Bulletin

Application: GM 4T40E/4T45E 1995-Up
Subject: Valve Body Gasket Revision

TB 2, 2/02

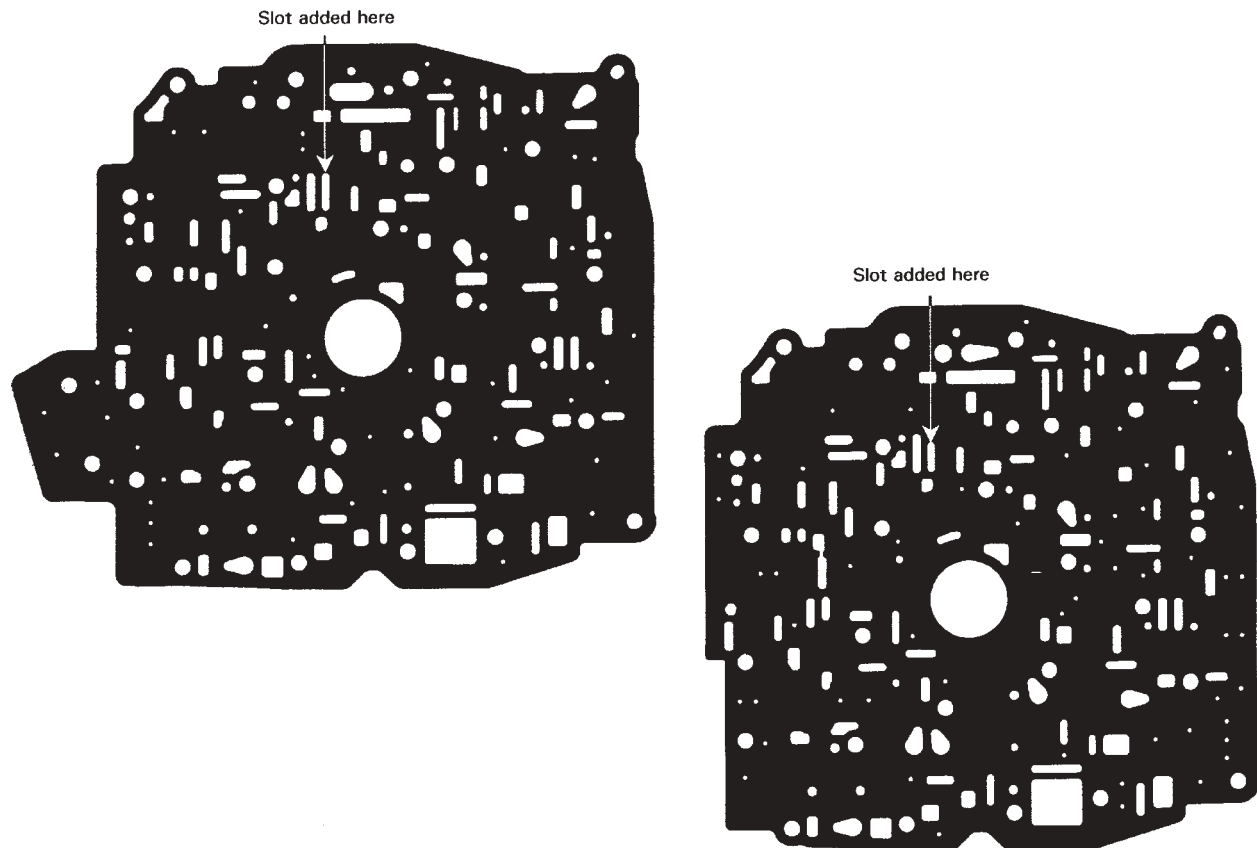
The valve body gaskets have been revised for all models of the 4T40E and 4T45E. A slot has been added to the upper and lower gaskets to correspond to the addition of a hole in the separator plate. The added slot does not interfere with the channel plate or valve body castings. The new gaskets, TransTec #12296 and #12297, WILL service ALL models of this unit from 1995-Up. The updated gaskets will replace the previous design in TransTec kits as stock is depleted.
